STAFF REPORT

REFERENCE: RM090875

SUBJECT: **SUSTAINABLE VENTURES LIMITED - REPORT REP10-05-11**
- Report prepared for the hearing of 12, 13 and 14 May 2010

Diagram 2: Vehicle Crossing

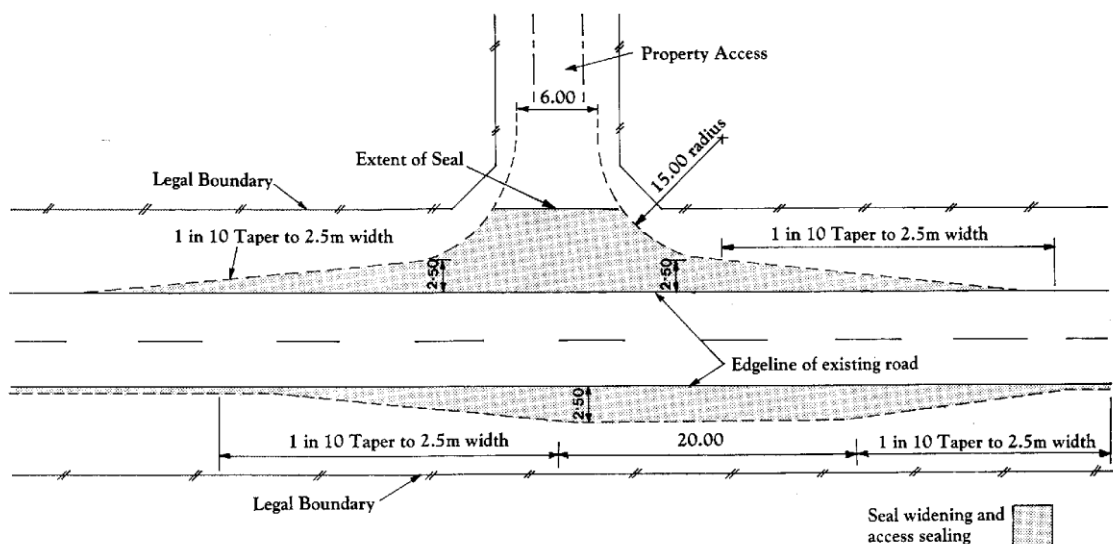
The vehicle crossing for Lot 2 shall be constructed in accordance with the design shown below:

and shall provide the following:

- The access crossing shall be at least 6 metres wide;

- b) the access sealing shall extend at least 5 metres inside the property boundary;
- c) provision of culvert crossings and water tables **where required**. The road culvert shall be to the approval of the Tasman District Council Engineering Manager;
- d) the access crossing shall be sealed in accordance with Tasman District Engineering Standards 2008;
- e) a road crossing permit shall be required from Council's Engineering Department. All works required under this permit shall be fully completed.

Figure 1: Access crossing for Lots 2 and 3, right-of-way A-D and Lot 10

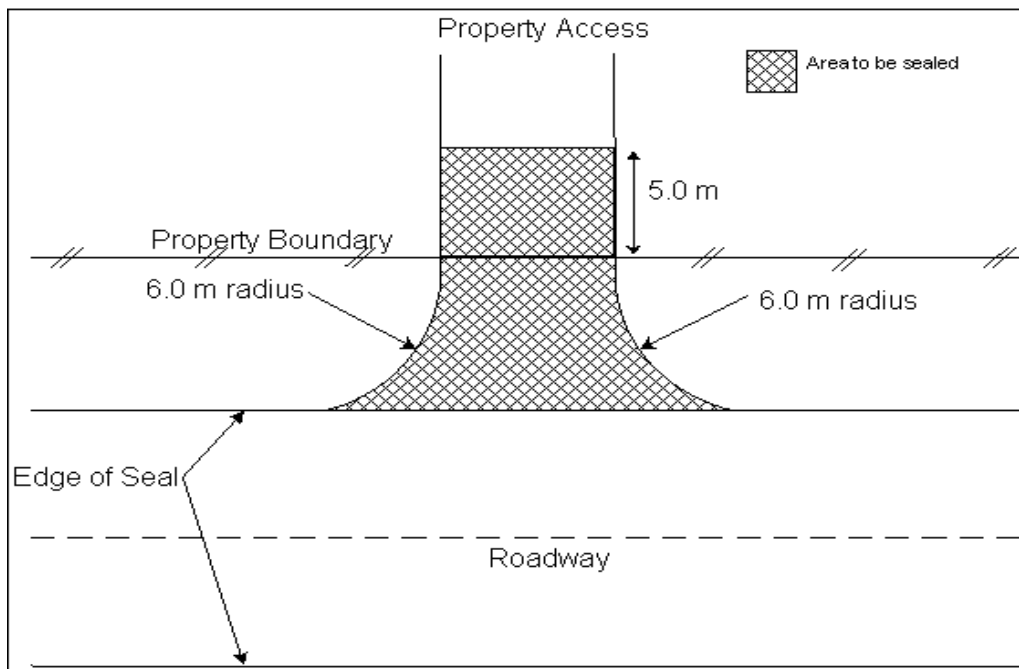
12. The right-of-way easement shall be set back at least 1 metre from the adjoining widened road reserve.
13. The Right-of-way formation shall be sealed in accordance with Council's Engineering Standards 2008.
14. Each of Lots 4-9 shall be provided with a 3 metre wide sealed access crossing from the right-of-way A-D, together with culverting if required. The sealing shall extend 5 metres inside the boundary of each allotment.
15. A 6 metre wide sealed access crossing for Lots 2 and 3, right-of-way A-D and a 3.5 wide sealed access crossing for Lot 10 shall be provided, together with culverting (where required), in accordance with Figure 1 below:

16. The above access crossings shall be sealed in accordance with Council's Engineering Standards 2008.
17. All construction earthworks relating to the access Conditions 11-16 shall need to comply with the Land Disturbance Consent RM090843.

Figure 1 – Proposed Subdivision

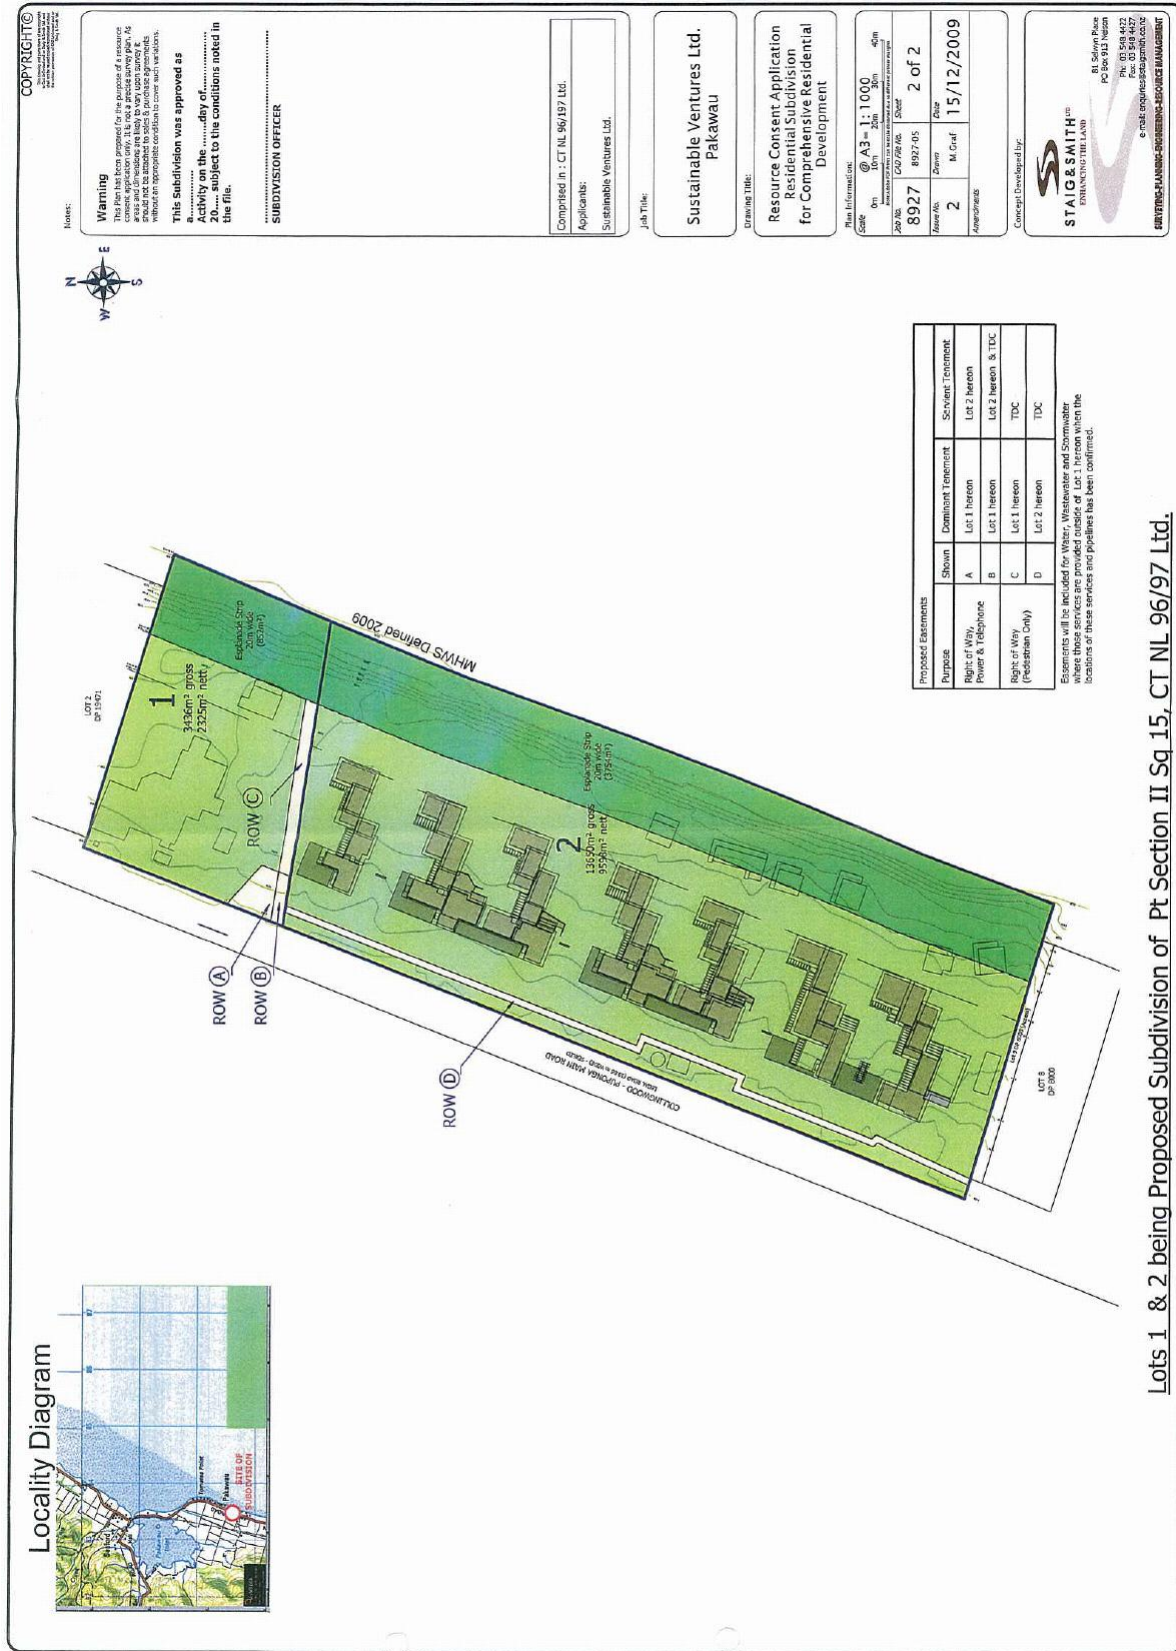
The application proposes the creation of a 20 metre esplanade, the applicants preference is to create the esplanade as a strip. The proposed subdivision also includes a right-of-way easement providing public access from the Collingwood-Puoponga main road to the esplanade reserve/strip and beach (See Figure 1).

The proposal shows two exit points to the Council road and the safety and sight visibility will be compromised if the hedge remains. The existing trees planted along the area will therefore be required to be removed together with any private structures occupying that area. Note, all that is required for the removal of the hedge is that the plants be sawn off at ground level and their root system can remain, ie no soil disturbance and disruption to archaeological sites (if any). Any other structures shall be removed and made safe.

With the road being vested along the front of the site the access/right-of-way may have to be relocated and may compromise future building area. It is my view that the subdivision plan showing the 5 metre wide road reserve should be presented to Council prior to the hearing so that staff can then reassess the resultant area left to develop.

Figure 2 – Aerial view of the property and surrounding reserves

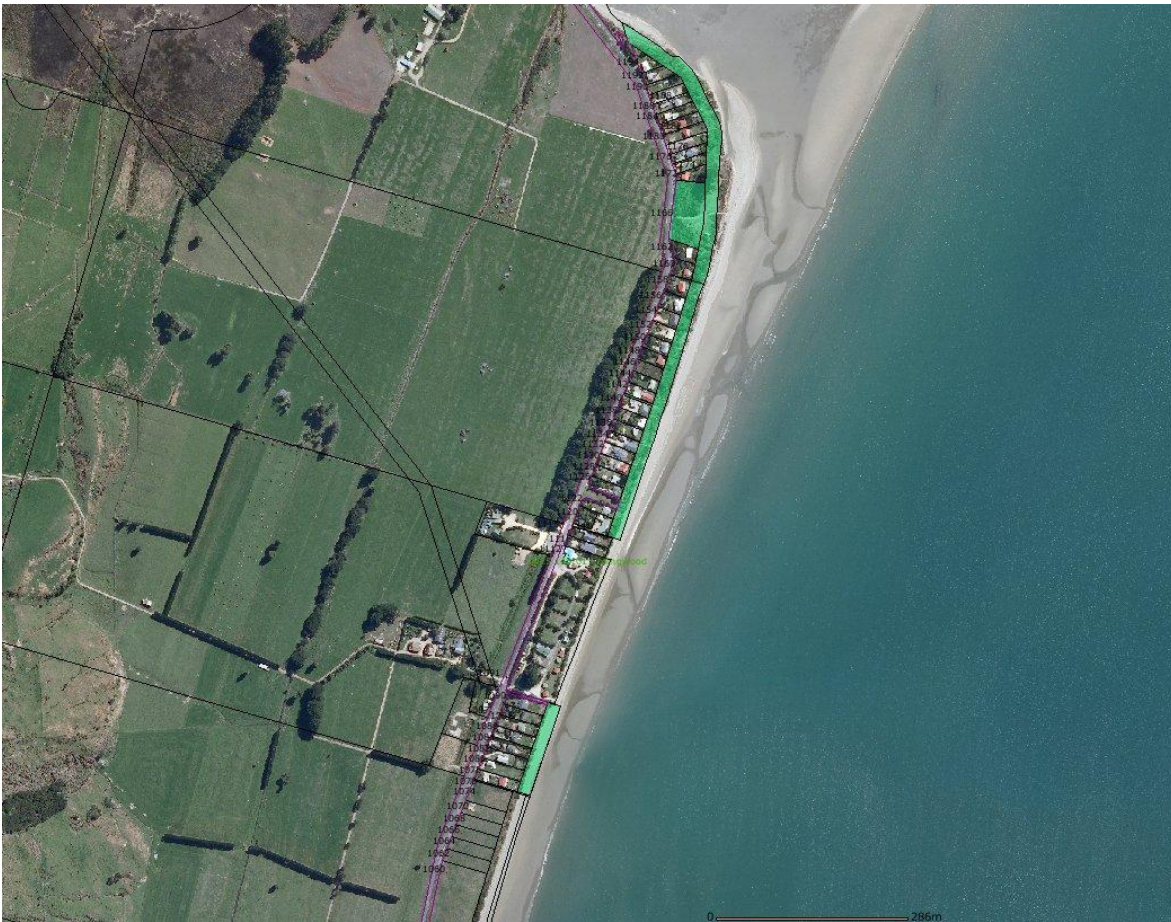
There is also an existing 3.6 metre wide public access way to the beach abutting the southern boundary of the property and an existing recreation reserve (Tomatea Point Recreation Reserve) approximately 450 metres to the north which provides pedestrian and boat access to the beach (See Figure 2).
